RE: RESPONSE TO COMMENT LETTER DATED AUGUST 31, 2021, AND UPDATED PROPOSED CITY OF HOUSTON STORM WATER SEWER ASSESSMENT WORK PLAN UNION PACIFIC RAILROAD COMPANY – HOUSTON WOOD PRESERVING WORKS HOUSTON, HARRIS COUNTY, TEXAS HAZARDOUS WASTE PERMIT/COMPLIANCE PLAN NO: 50343, ISWR NO 31547 EPA IDENTIFICATION NO TXD000820266; RN100674613/CN600131098

UPDATED PROPOSED CITY OF HOUSTON STORM WATER SEWER ASSESSMENT WORK PLAN

TITLE
 STORMWATER SEWER EVALUATION - LIBERTY ROAD

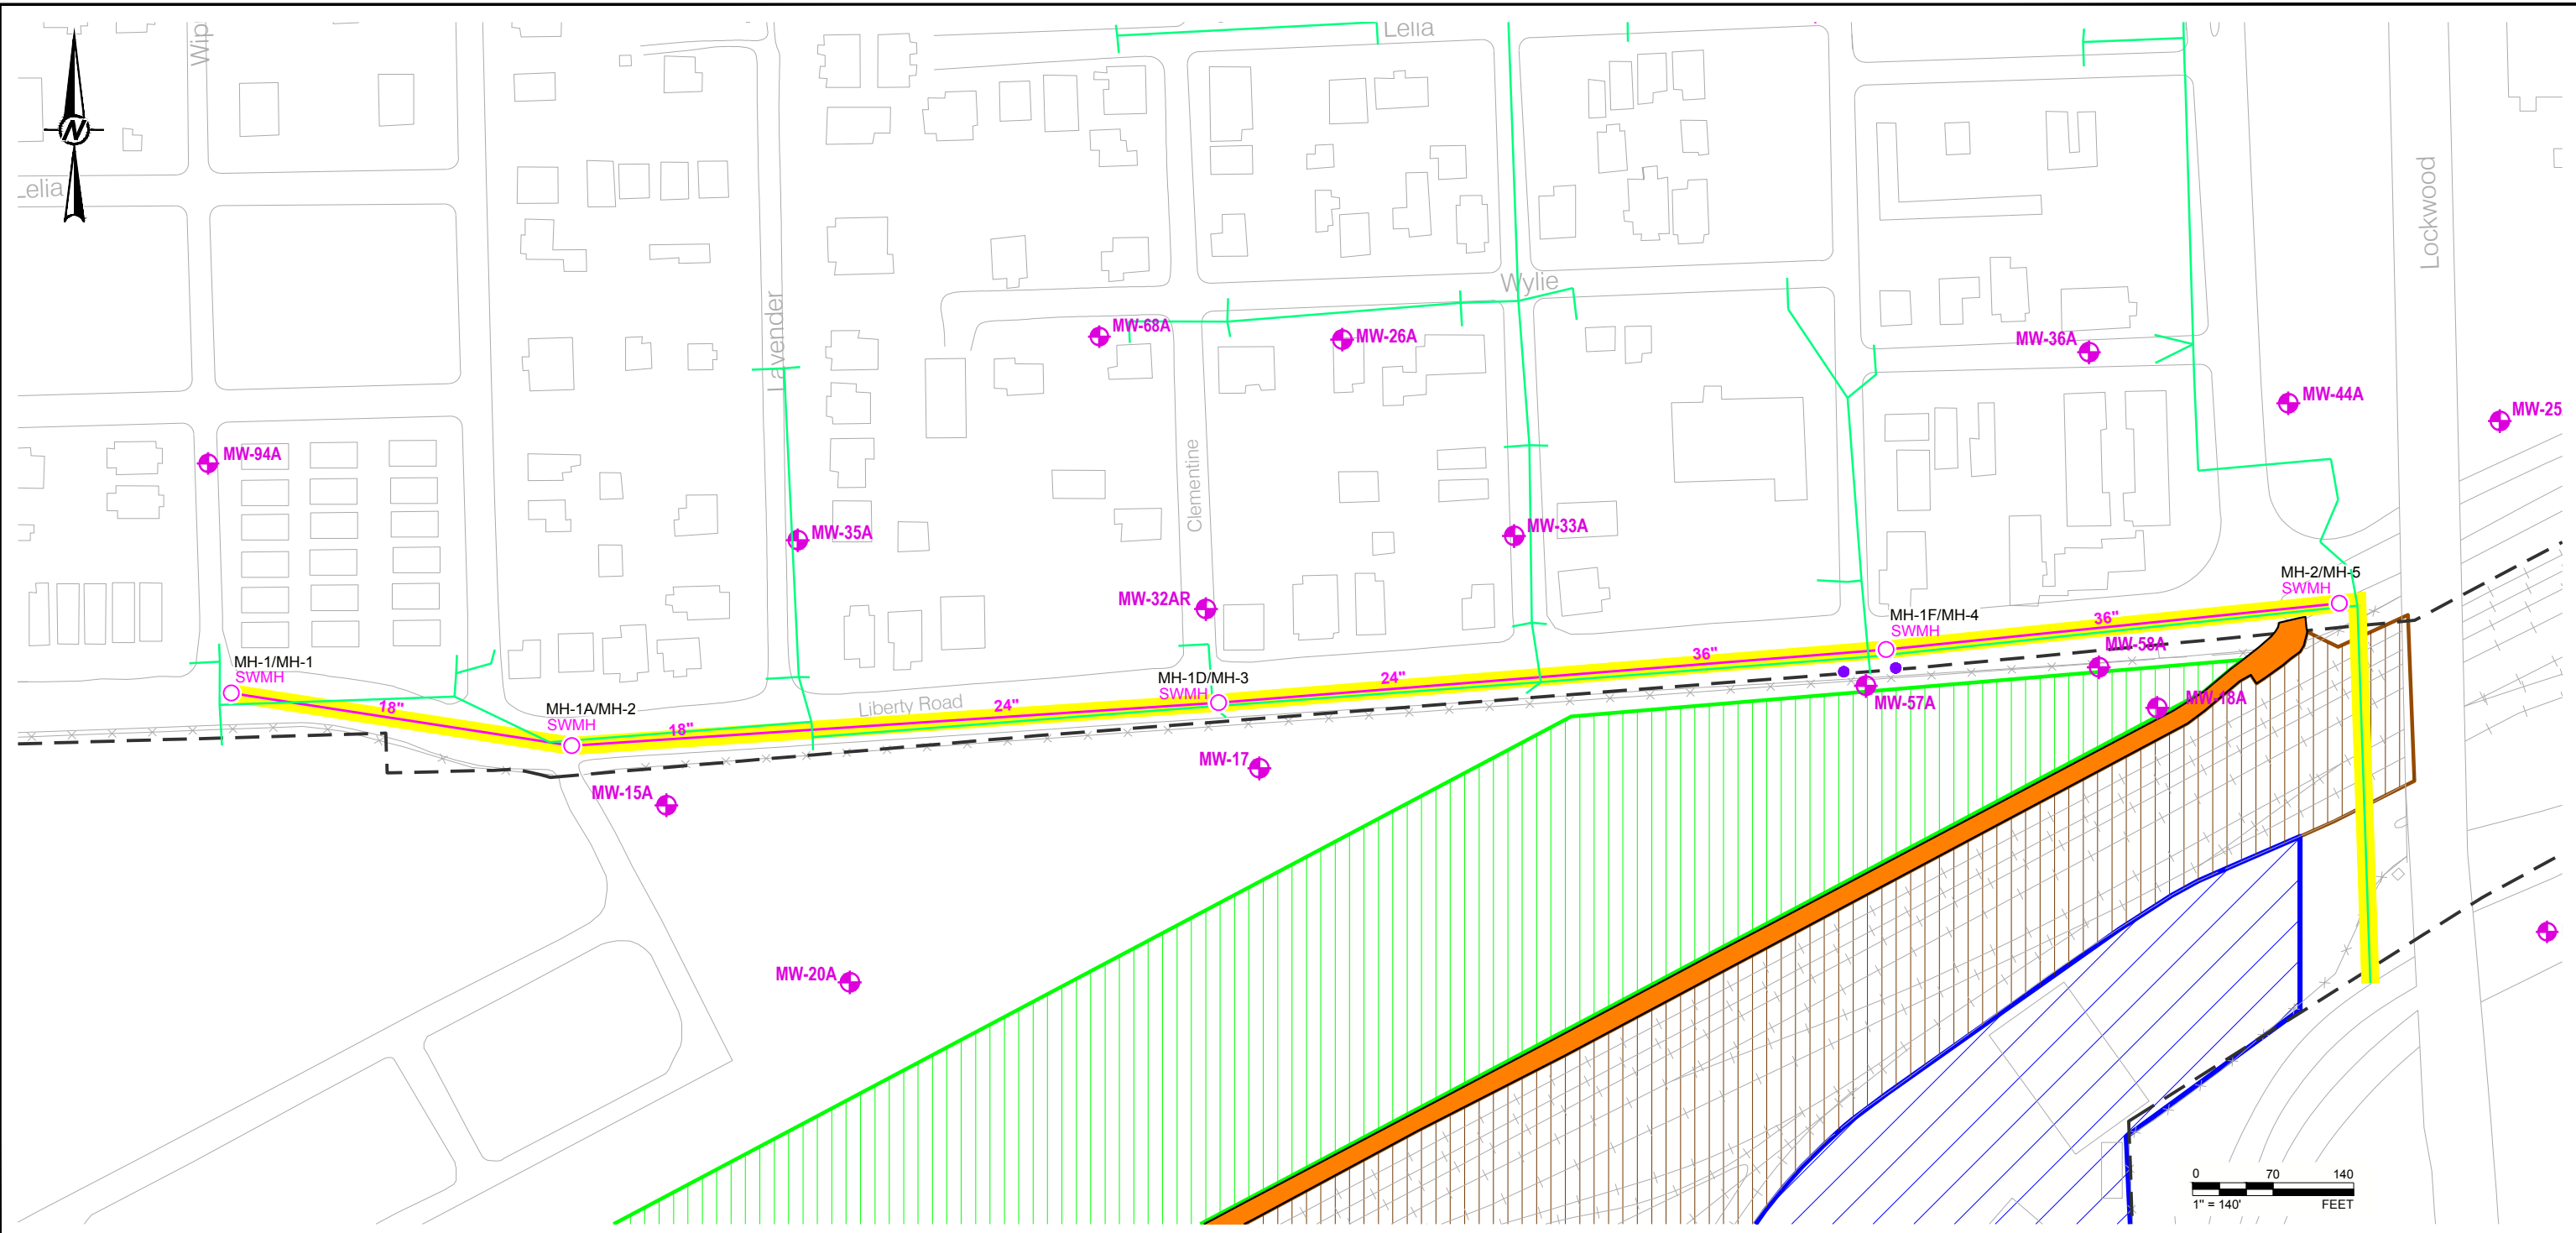
TCEQ Comment 1. A minimum of two additional monitor wells should be installed next to the Storm Drain in proximity to the A-TZ monitor wells containing non-aqueous phase liquid (NAPL) along the northern and eastern property boundary.

Response: As requested, UPRR will install two additional temporary wells near MW-57A in the approximate locations shown on Figure 1 (for a total of five temporary wells). The proposed locations may be adjusted based on field conditions (i.e., other underground utilities). These two additional temporary wells will be installed and plugged and abandoned following the procedures outlined in the scope of work presented below. It should be noted that, as indicated in the *DNAPL Recovery Activities*

Quarterly Report – 2nd Quarter 2021 dated July 28, 2021, and submitted to the TCEQ, none of the A-TZ wells along the northern and eastern property boundary have had measurable DNAPL since August 2015. Monitoring well MW-57A located along the northeast perimeter of the Site (see Figure 1) last had measurable DNAPL on August 3, 2015, following approximately 2.5 years of monthly manual recovery from the well.
